Louisville 6s Reheats – RFIs 1 thru 18

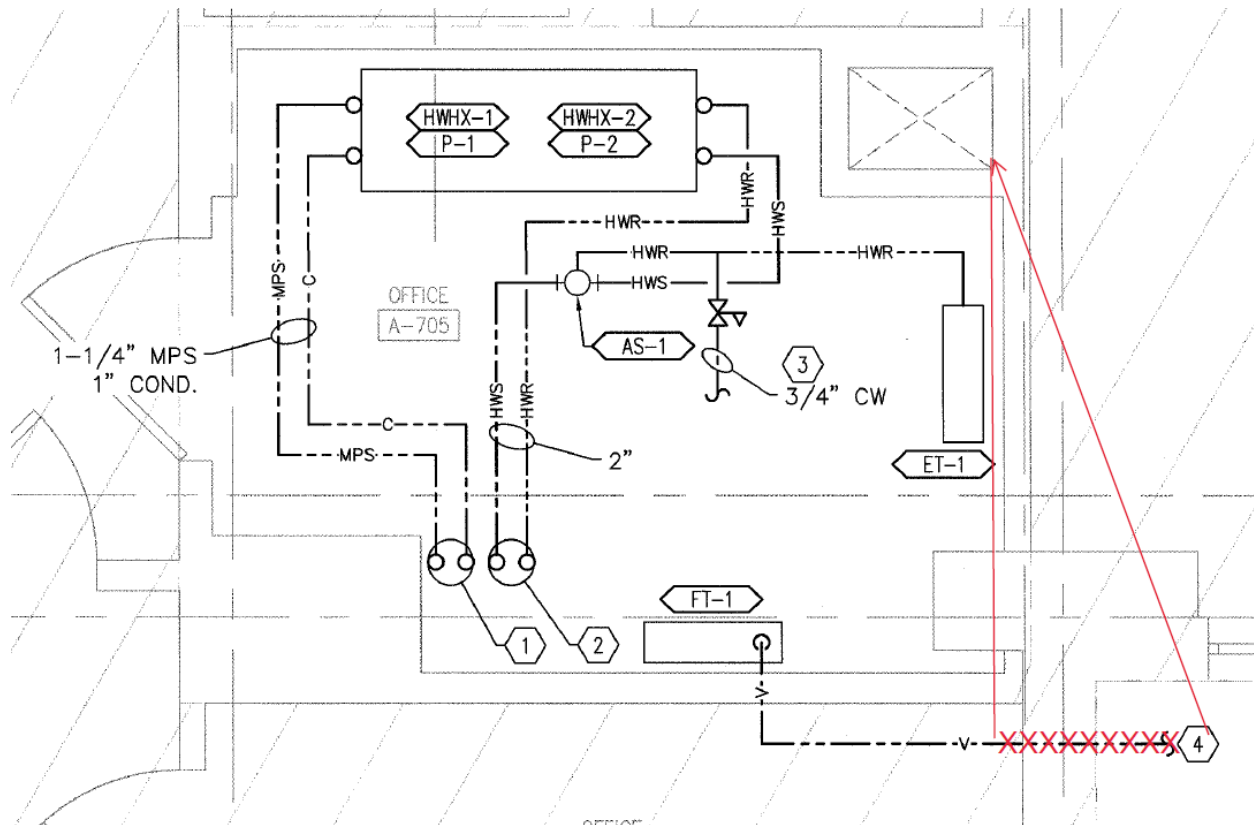
EL101 indicates lighting in corridor and west side rooms shall be connected to emergency power lighting. Are existing lights connected to emergency power or will new circuits need to be ran to these lights?

Same as above, where is the emergency power panel located?

Paradigm Response: Refer to keyed Notes No. 1 and No.2 on drawing EL101.

Paradigm Response: Refer to keyed Notes No. 1 and No.2 on drawing EL101.
